Reason document for the final draft Specification no. TI/SPC/RCC/SCADA/0133 for SCADA system for 25 kV Single Phase 50Hz ac Traction Power Supply.

13.	1.2/50 μ s Impulse voltage withstand test as per IEC 60870-2-1	OFF	2 kVp				No break down or flashover	Complied Need to specify the Class from IEC 60870-2-1 VW1- 1 kV VW2- 2 kV VW3- 5 kV	VW3 has been specified

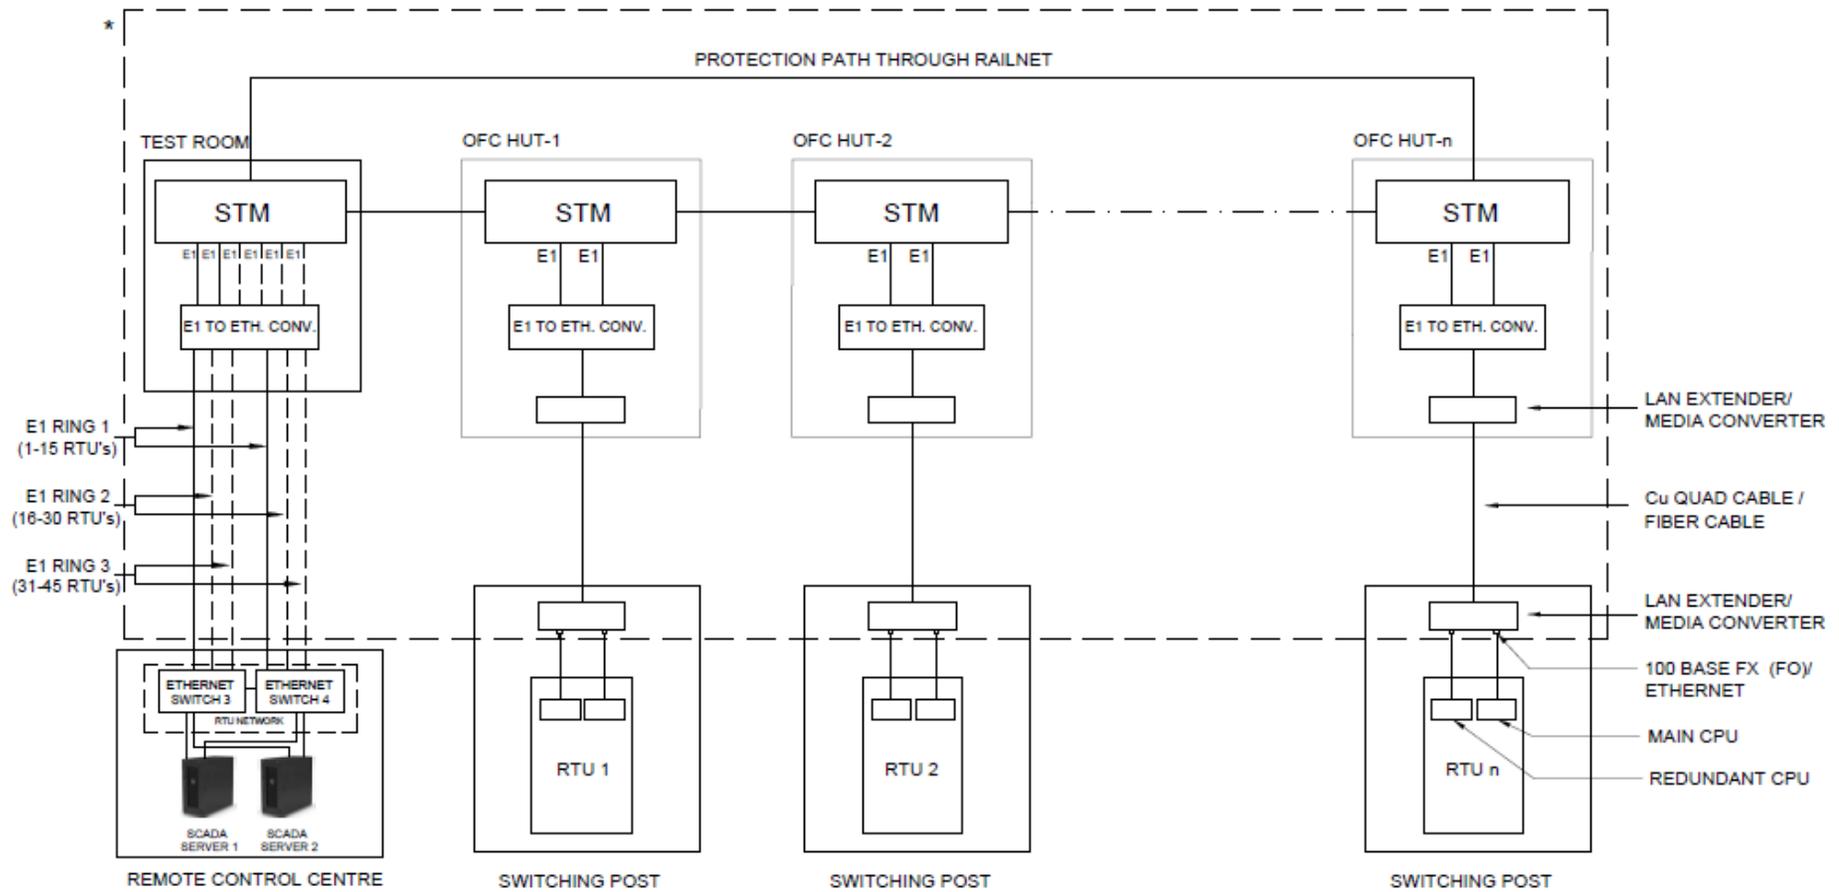
12.	Power Frequency Voltage with stand Test as per IEC 60870-2-1	OFF	2kVrms for 1 minute				No break down or flashover	Complied Comm- 1.6 Kv for 60 sec I/O & PS- 3 Kv for 60 Sec Need to specify the Class from IEC 60870-2-1 VW1- 0.5kV VW2- 1kV VW3- 2.5kV Classes VW1 and VW2 are preferred for equipment operating at d.c. voltages below 60 V. Classes VW2 and VW3 are valid for supply voltages up to 250 V.	VW3 has been specified

Classes VW1 and VW2 are preferred for equipment operating at d.c. voltages below 60 V. Classes VW2 and VW3 are valid for supply voltages up to 250 V.
